STATE OF FLORIDA DEPARTMENT OF TRANSPORTATION
WATER QUALITY IMPACT EVALUATION CHECKLIST

Project Name:	US 301 PD&E Study
County:	Hillsborough & Pasco
FM Number:	255796-1-22-01
Federal Aid Project No:	N/A
Brief Project Description:	The Florida Department of Transportation (FDOT), District Seven, is conducting a Project Development and Environment (PD&E) Study for the proposed improvements to US 301 from Fowler Avenue (SR 582) in Hillsborough County to SR 56 in Pasco County. The total project length is approximately 13.1 miles. The proposed action includes widening US 301 from two lanes to four lanes and providing pedestrian and bicycle accommodations.

RE: US 301 PD&E from Fowler Avenue to SR 56; FPID 255796-1-22-01; Revised SMF and FPC sites per Longlist meeting comments

RE: US 301 PD&E from Fowler Avenue to SR 56; FPID 255796-1-22-01; Longlist Pond Siting Meeting

US 301 from Fowler to County Line Area Proposed Stormwater Projects

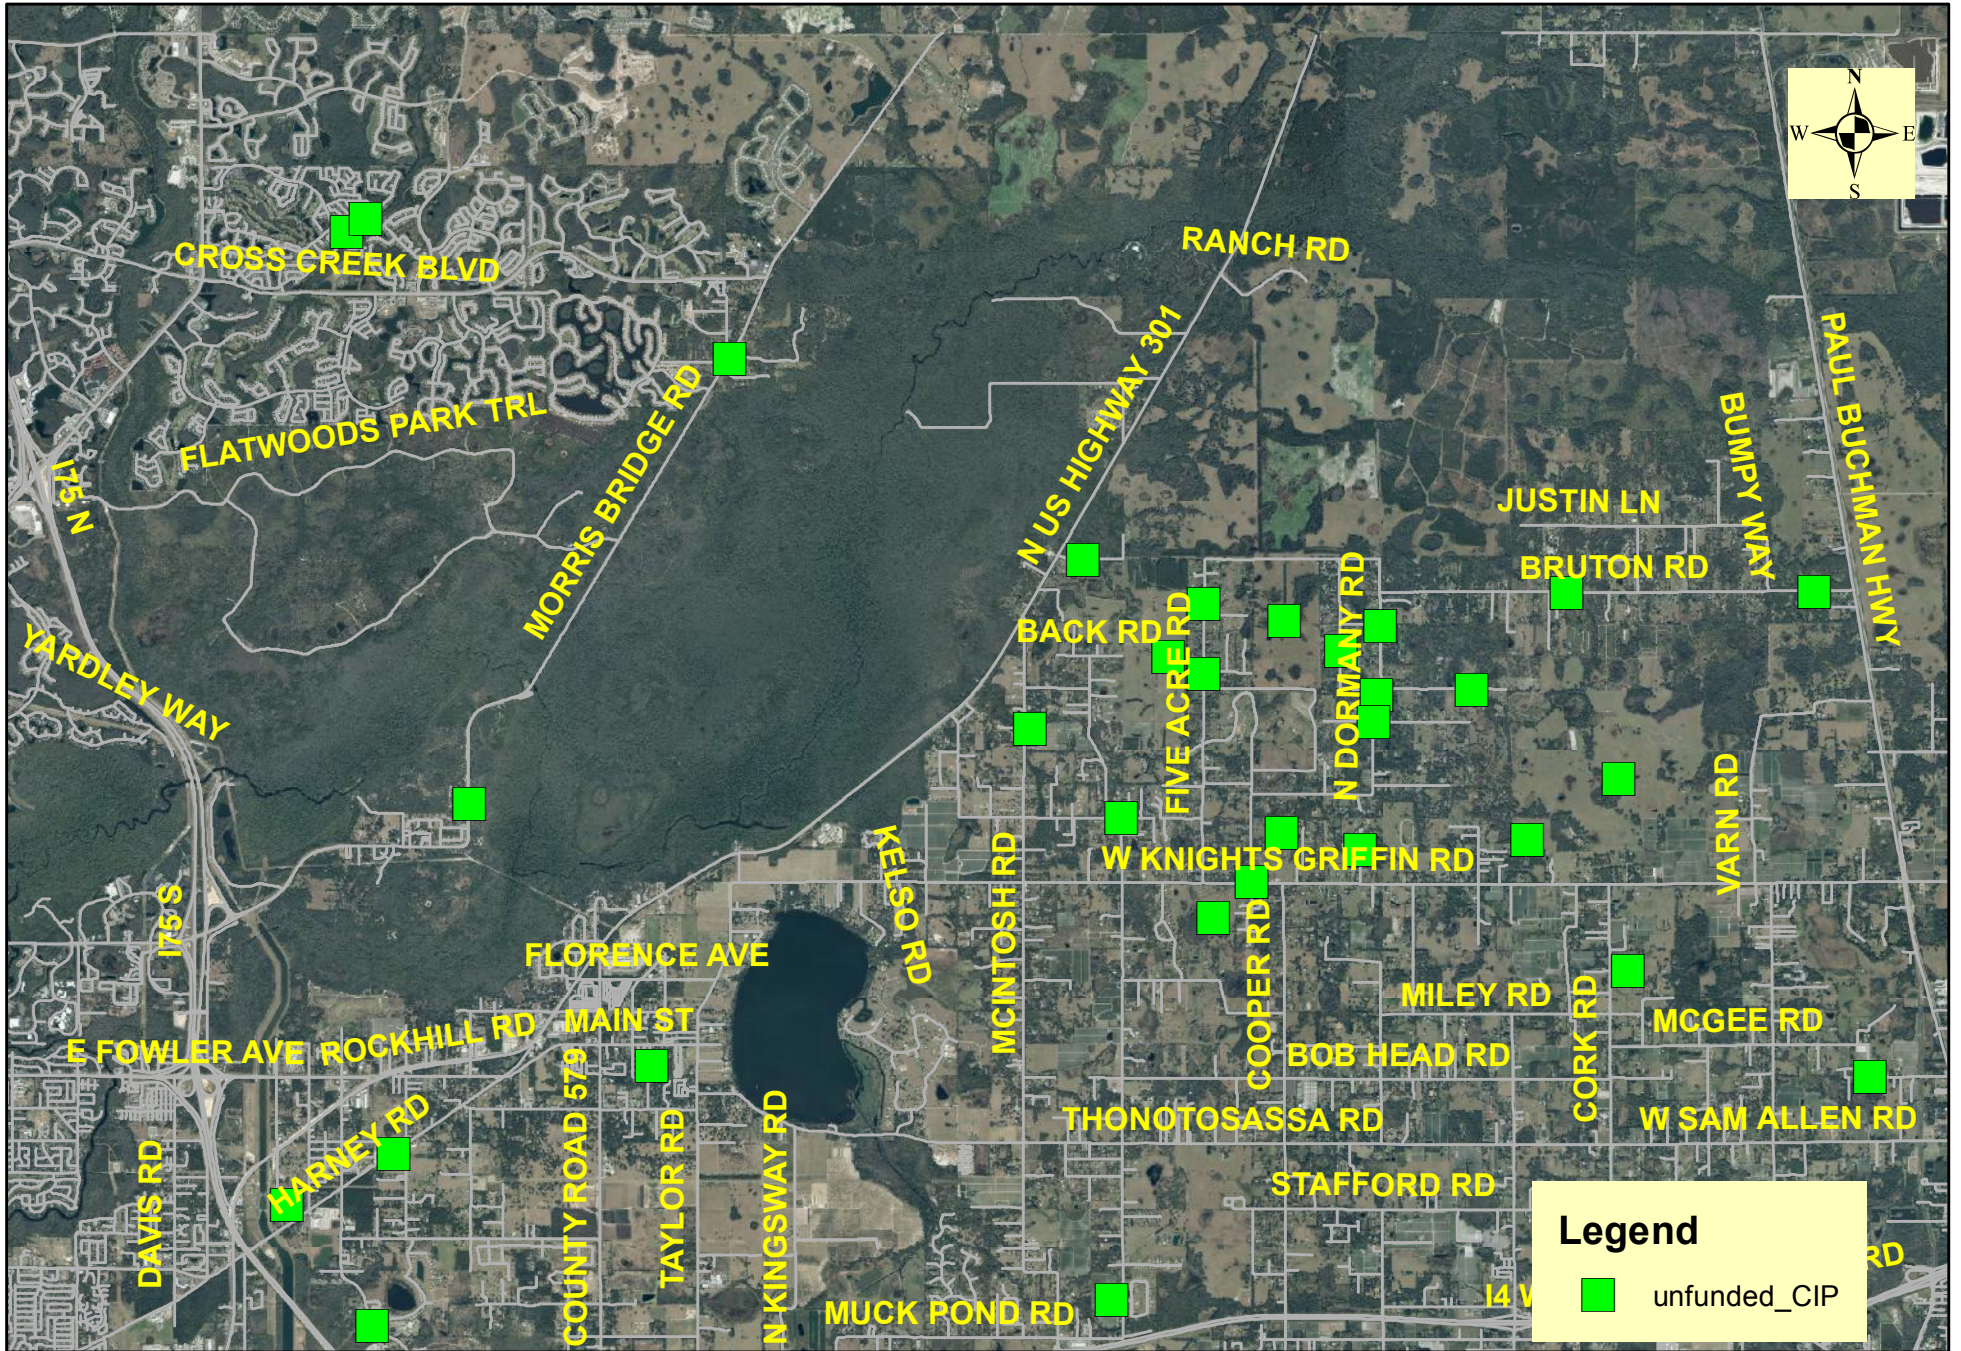
Attached please find a map showing the proposed stormwater projects in this area.
